ADDENDUM NO. 1

RE: Indiana University Bloomington
BL157 Fine Arts, Rm 145
Ceiling/Lighting/Spray Booth

PROJECT No.: 20200820

DATE: March 24, 2026

D WALL TYPE 'A' DETAIL
SCALE: 1 1/2" = 1'-0"

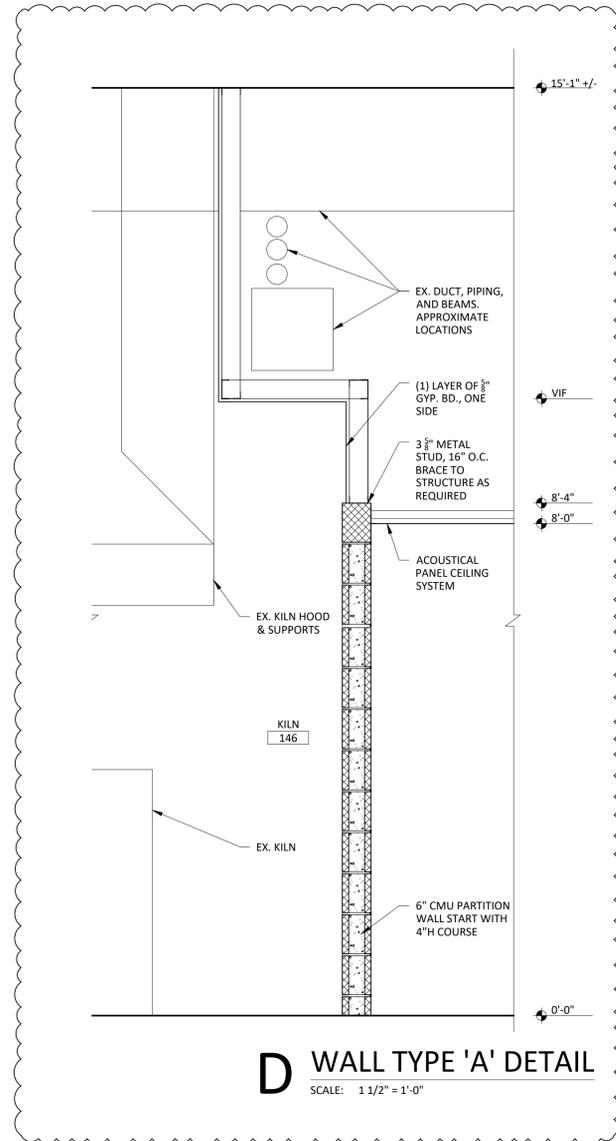
1. Sheet A501 – SCHEDULES AND DETAILS, see attached.
 - a. DOOR & FRAME SCHEDULE
 - i. Revise Head and Jamb detail reference to H1 & J1, see attached.
 - b. Add D/A501 WALL TYPE ‘A’ DETAIL, see attached.

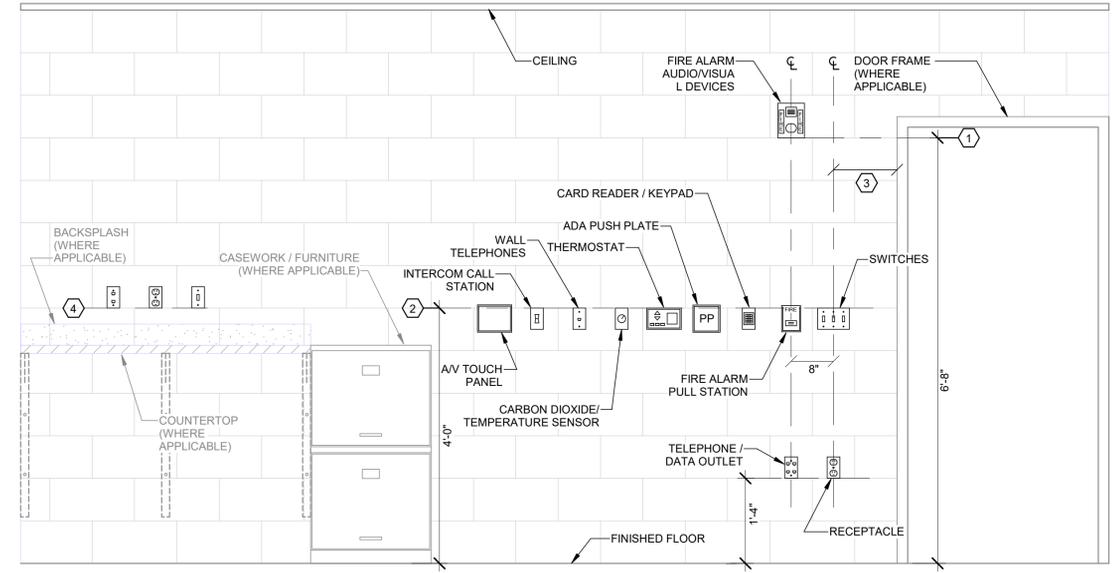
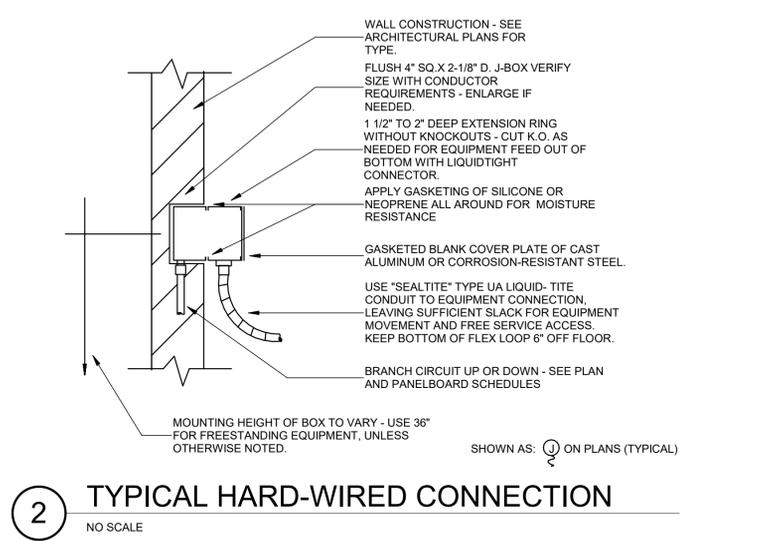
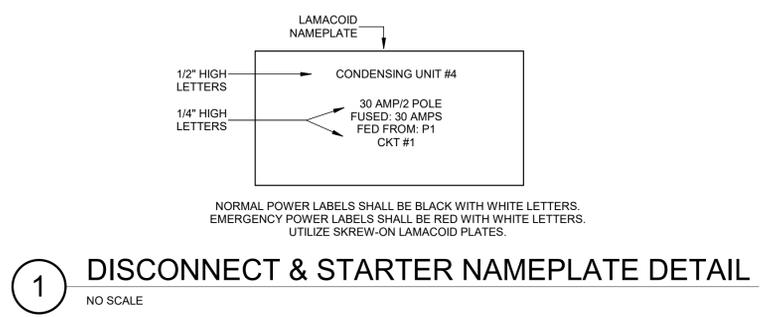
2. Sheet E202 – ELECTRICAL DETAILS
 - a. See attached plan for added scope of new conduit through area of work.
